Email: info@edac.net **ENGINEERING CHANGE NOTICE**

Date:	Document Number
July 30, 2021	ECN20210729-00
Revision Number	SHEET
1	1 of 3

Discontinuance / End of Life of Part No- 690-024-232-031 (USB 3.1 TYPE C FEMALE)

698C124-205-211

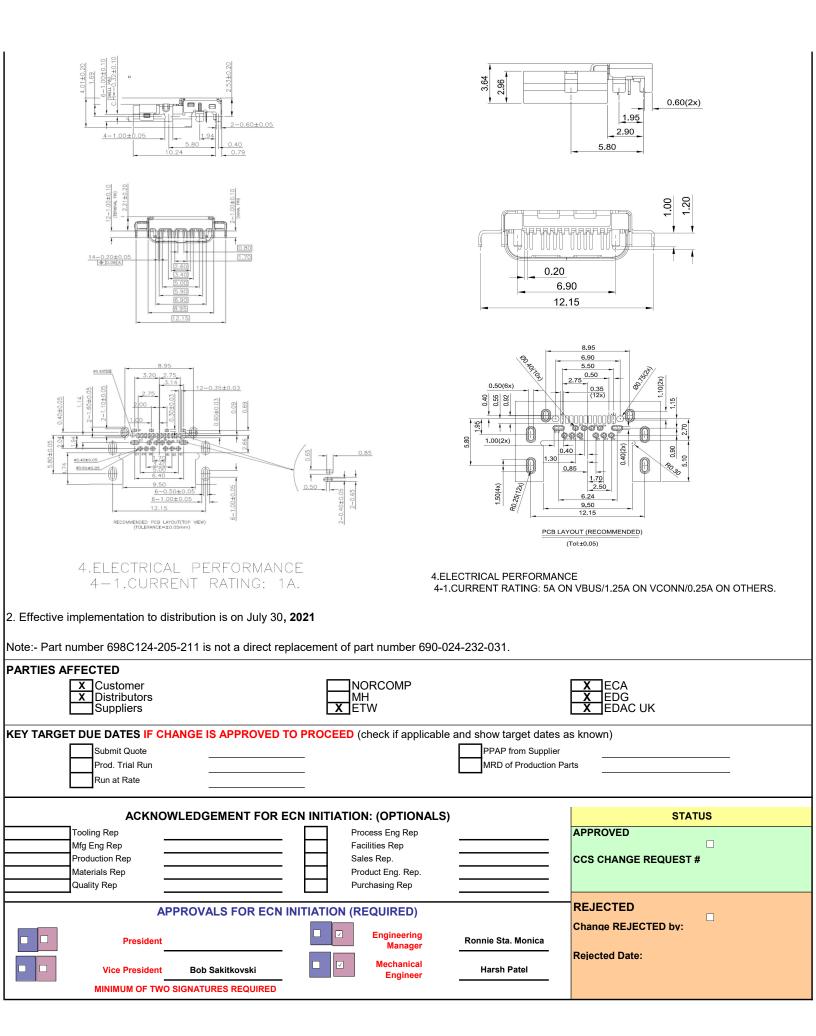
- 1. Tooling of Part No- 690-024-232-031 has worn out.
- 2. Part No- 690-024-232-031 is Obsolete. Equivalent part number is 698C124-205-211 Old Drawing No 690-024-232-031, Rev-01
